UNITED STATES PATENT AND TRADEMARK OFFICE

APPLICATION NO.	FILING DATE	FIRST NAMED INVENTOR	ATTORNEY DOCKET NO.	CONFIRMATION NO.
10/619,556	07/16/2003	Greg Parker	553-74	5931
23117	7590	03/09/2005	EXAMINER	
NIXON & VANDERHYE, PC 1100 N GLEBE ROAD 8TH FLOOR ARLINGTON, VA 22201-4714			PAK, SUNG H	
			ART UNIT	PAPER NUMBER
			2874

Office Action Summary

DETAILED ACTION

FIG. 1

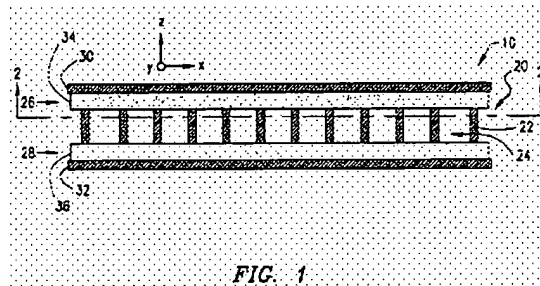
Sigalas discloses an optical device with all the limitations set forth in the claims, including: a photonic crystal waveguide comprising a core layer (composed of air slab body and rods- column 4 lines 17-25; '20' Fig. 1) having a first refractive index n_{core} (the effective refractive index of the core layer is determined by the refractive index of air slab body and the refractive index of dielectric rods); array of sub-regions within the core layer having a second refractive index n_{rods} ('22' Fig. 1); wherein the sub-regions are formed from silicon (column 4 lines 19-20), and the sub-region gives rise to a photonic bandgap (column 1 lines 14-25). Since the core layer is composed of air slab body (which has a refractive index of 1) and silicon rods (which have refractive indexes of 3-4, column 6 line 3), n_{rods} is necessarily greater than the effective refractive index of the entire core layer n_{core} by at least 0.1.

Sigalas also discloses the waveguide structure being a planar waveguide structure (Fig. 1); the core layer being formed between a cladding layer (i.e. upper cladding '26' Fig. 1) and a buffer layer (i.e. lower cladding '28' Fig. 1); wherein the refractive indexes of the cladding and the buffer layers are less than n_{core} (column 6 lines 8-12); wherein the cladding layer is formed from silicon dioxide (column 4 line 53); wherein the array of sub-regions are arranged in a square lattice (Fig. 2); wherein the core layer includes a waveguiding region having no sub-
